Product Change Notification / ASER-25RLDG830

CCB 4279.002 Final Notice: Qualification of GTK as a new assembly site for selected SST39VF3201xx and SST39VF3202xx device families available in 48L TSOP (12x20mm) package.

LPI

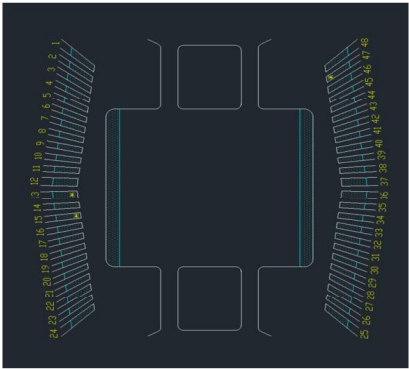
Pre Change:Assembled at LPI using 8340 die attach material, G700 mold compound and 183x161 mils lead frame paddle size.

Paddle size	183 x 161 mils
-------------	----------------

GTK

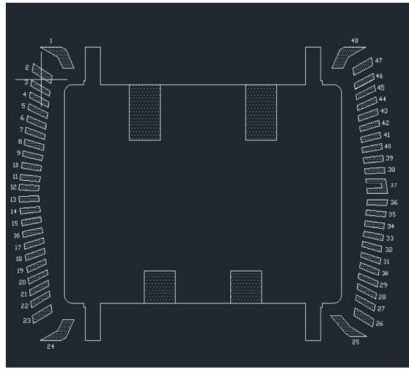
Post Change:Assembled at GTK using EN-4900GC die attach material, G600F mold compound and 280x210 mils lead frame paddle size.

Paddle size	280 x 210 mils
-------------	----------------
